PLANNING COMMISSION MEETING

RE: White Lake Retail Building-9197 Highland Road - Preliminary Site Plan Review- 2nd Review

Amended Site Plan / Planned Business Review for White Lake Charter Township, Michigan

Re: Site Plan Approval
9197 Highland Rd.

PROJECT LOG	
FILE:	2025-429
PROJECT MGR:	JDM
DESIGNED BY:	FR
DRAWN BY:	FR/JP
CHECKED BY:	
SCALE:	1" = 20'
SHEET:	1 OF 1

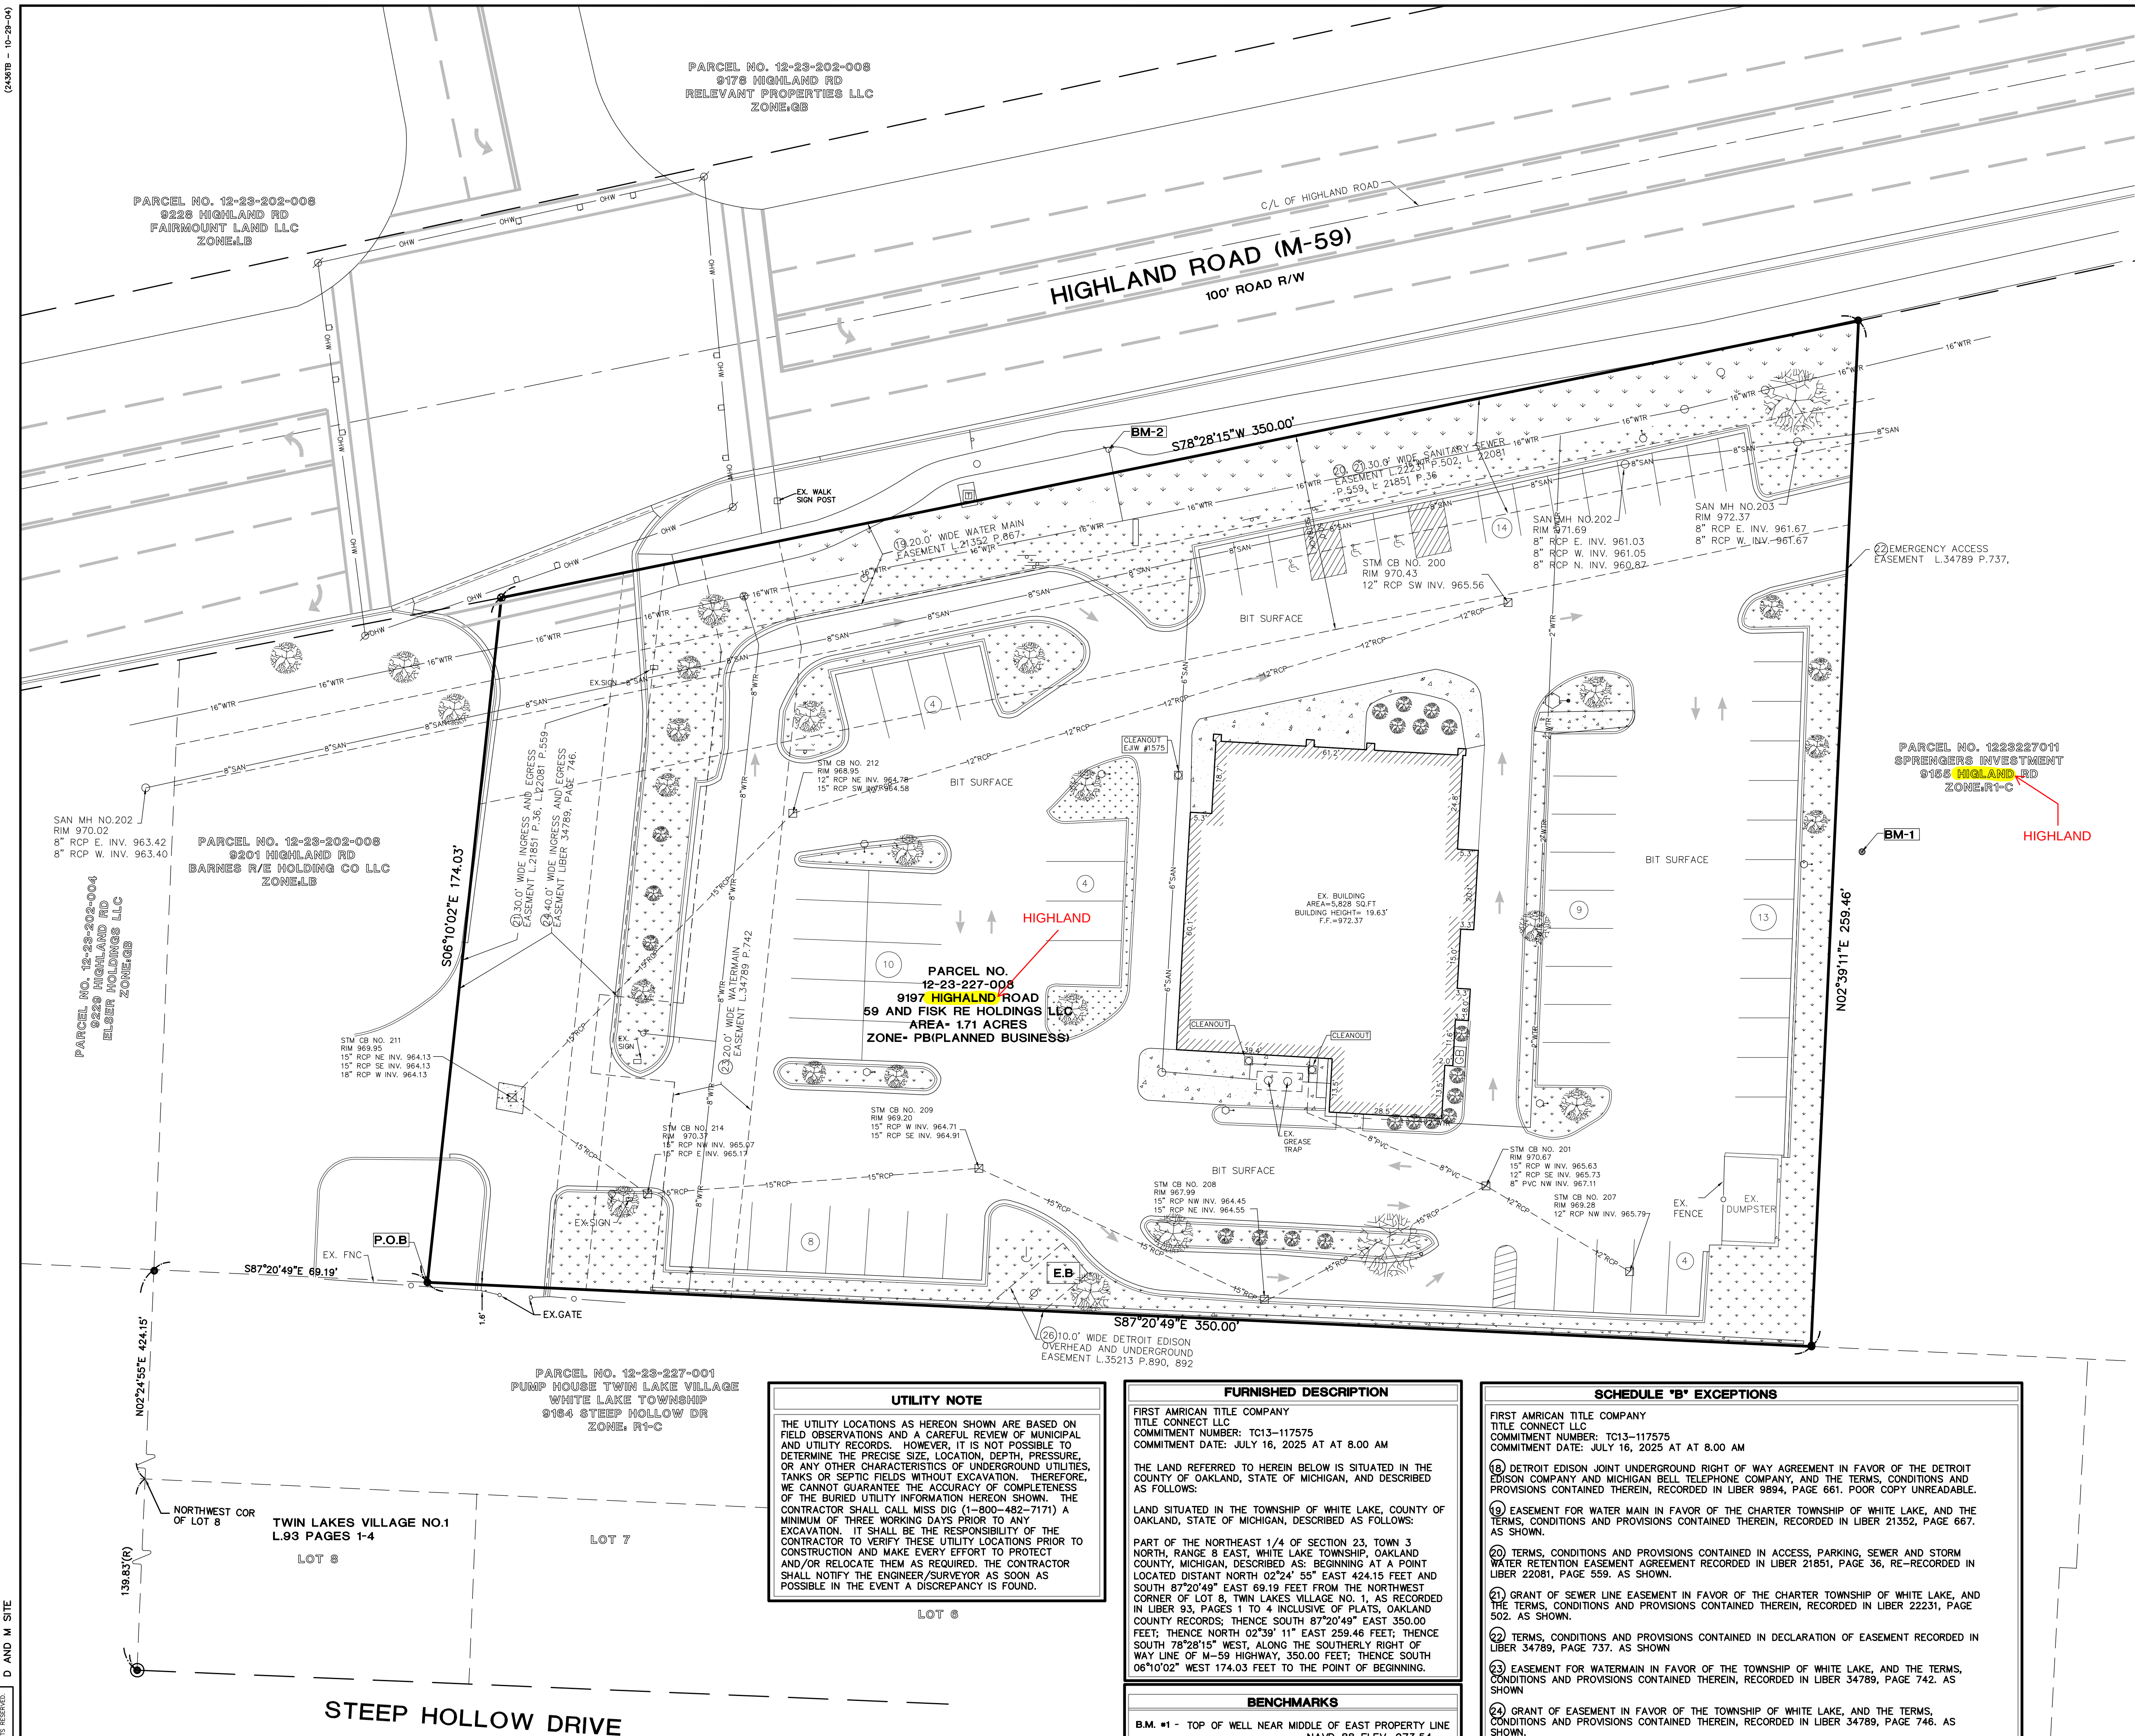
6. *Sheet 1- Please correct spelling of 'Highland' in two areas on this sheet.* **Comment remains; errors are on the parcel callouts for the subject property and the property to the east, see attached markups.**

1. **Comment addressed and removed from this list.**
2. *Sheet 1- There are additional cleanouts for the sanitary sewer lead not shown. In addition, the existing sewer leads from the building are not correctly shown. We recommend the surveyor contact our office for the Wendy's/Tim Hortons's AB drawings.* **Comment addressed.**
3. *The condition of the existing 1000 gallon grease trap shall be evaluated and required maintenance performed. In addition, a 4' diameter monitoring manhole is required prior to discharge to the*

existing 8" diameter sanitary sewer along the M-59 frontage per Township Engineering Design Standards (Section E.8). A note has been added to the plan set indicating that the contractor will inspect the existing grease interceptor and provide maintenance as necessary. We defer to Township DPS if any further action is required.

1. *Sheet 1- The layout and diameter of the 6" PVC storm sewer lead from building is incorrect. Lead is shown as 8" diameter and in a different location per AB drawings for Wendy's/Tim Hortons plan. In addition, the diameters of some of the existing storm sewer shown are incorrect. We recommend the surveyor contact our office for the Wendy's/Tim Horton's AB drawings. Comment addressed, storm layout has been updated to match As-Built plans.*
2. Comment addressed and removed from this list.
3. Comment addressed and removed from this list.
4. Comment addressed and removed from this list.

6. Sheet 1- Please correct spelling of 'Highland' in two areas on this sheet.
Nothing to comment on this remark regarding the Survey Sheet.

1. Sheet 1- The existing 8" sanitary sewer now extends to the eastern property line.....
No Comment Needed / The line has been extended to the east on the plan.
2. Sheet 1- There are additional cleanouts for the sanitary sewer lead not shown. In addition.....
The additional cleanouts have been added to the Survey Plan.
3. The condition of the existing 1000 gallon grease trap should be evaluated and required.....
This is an existing system that will be operationally addressed during the renovation of the building. The existing system is to inspected and any maintenance needed to be provided. Any tenants needing a grease interceptor shall have information provided as such on their tenant improvement plans.

SHEET NO. AS-1

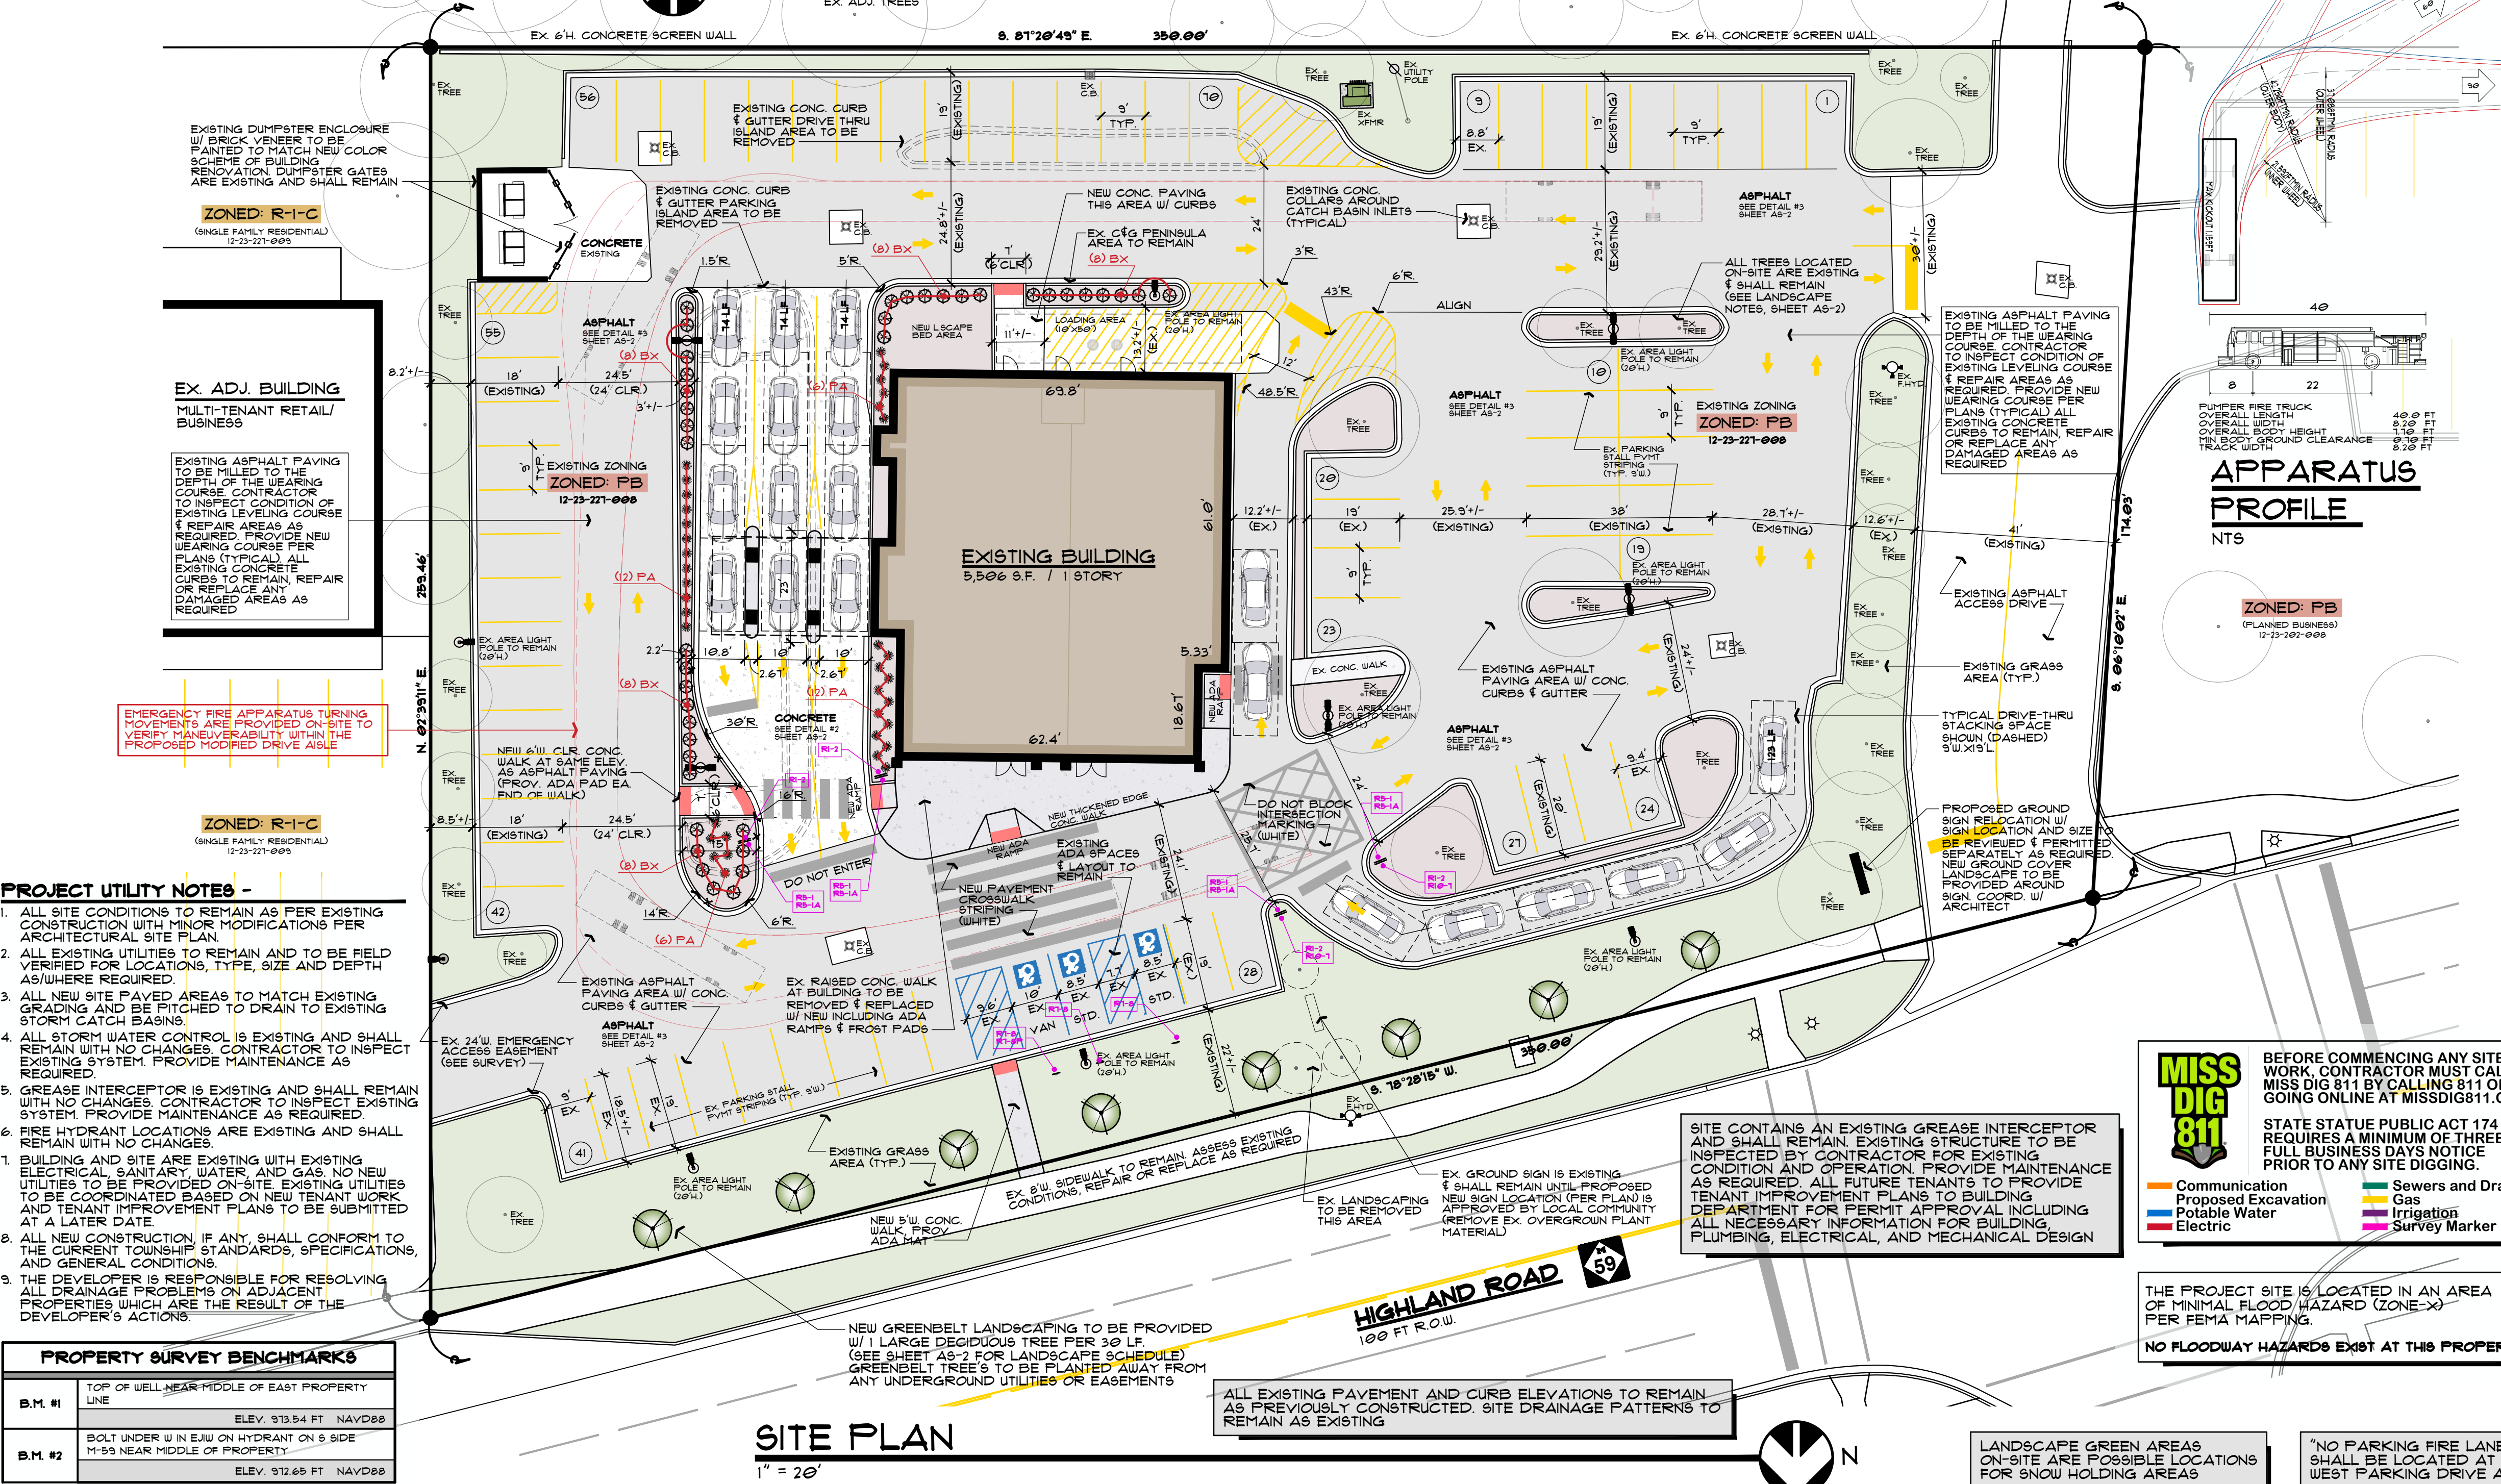
1. *Provide a fire truck turning plan for a standard 40 foot long fire truck.* **Comment addressed, a turning radius has been provided on plan sheet AS-1 demonstrating acceptable access.**

2. *Sheet AS-1- Provide length dimension for drive through stacking space on this plan sheet.* **Comment addressed, the stacking space has been shown at 74 feet long.**

3. *Sheet AS-1- Provide dimensions for ADA spaces and associated loading zones.* **Comment addressed, additional dimensions have been provided and the parking spaces appear to meet minimum requirements.**

4. *Sheet AS-1- We recommend that the crosswalk striped area adjacent to the proposed ADA spaces be designated for pedestrian use only and not for pass through of vehicles in this area. It is recommended that a "Do Not Enter" and/or "No Vehicular Traffic" sign(s) be placed on both the west and east sides of this crossing. Applicant has indicated this is an existing condition and is intended to be left in similar condition. We understand the conditions exist but note that ADA access to the building is less than ideal. We defer further comment to Township Planning Department.*

5. *Sheet AS-1- Northernmost parking area- Space length measures to 18.5' B/C (NE area) and 18' 2" B/C (NW area). In addition, the following spaces do not appear to meet the requirements of WLT Zoning Ordinance 5.11 Q for parking space dimensions: a) Space with '9' on it; b) Space with '41' on it; c) Space with '24' on it. Existing dimensions have been provided and some areas are short of the 19 foot depth requirement, The shortest dimension shown is 18 foot of depth. We defer to Township Planning if this will require a waiver since this is existing conditions.*

6. *Sheet AS-1- The two-way drive just NE of the "Do Not Block intersection marking (white)" appears to be <24' in width. A minimum 24' width is required for a two-way drive (Zoning Ordinance 5.11 Q v).* **Comment addressed, dimensions have been provided and meet the minimum requirement of 24 feet wide.**

1. Provide a fire truck turning plan for a standard 40 foot long fire truck.
This has been shown on our Sheet AS-1
2. Sheet AS-1- Provide length dimension for drive-thru stacking space on this plan sheet.
Stacking is already shown on the plan (AS-1) with added dimensions.

3. Sheet AS-1- Provide dimensions for ADA spaces and associated loading zones.
The information is already indicated on the plans. The Loading Area is shown and noted on Sheet AS-1 and the ADA Parking Space information, dimensions, notes and details are clearly indicated on Sheet AS-1 & AS-2 Detail 5. The dimensions exceed required minimums.

4. Sheet AS-1- We recommend that the crosswalk striped area adjacent to the proposed ADA.....
*This area **will not be** marked with "No Vehicular Traffic" signage. This is the main drive aisle and circulation for the site and will remain as originally approved & constructed for the prior development. The suggested change would prohibit cars from entering the area to even park in the ADA spaces. This **is not** a functional or practical recommendation.*

5. Sheet AS-1- Northernmost parking area – Space length measures to 18.5' B/C (NE area).....
This is an existing approved and already constructed site that will remain unchanged per our plan information. The parking spaces referenced are all existing and shall remain dimensionally as presently indicated on the Site Plan. All dimensions are shown on the plan which meet the ordinance. All comments are based on the information we have.

6. Sheet AS-1- The two-way drive just NE of the "Do Not Block" intersection marking appears.....
This is an existing approved and already constructed site that will remain unchanged. Per the information we have regarding the site all dimensions are correct as noted on the plans.
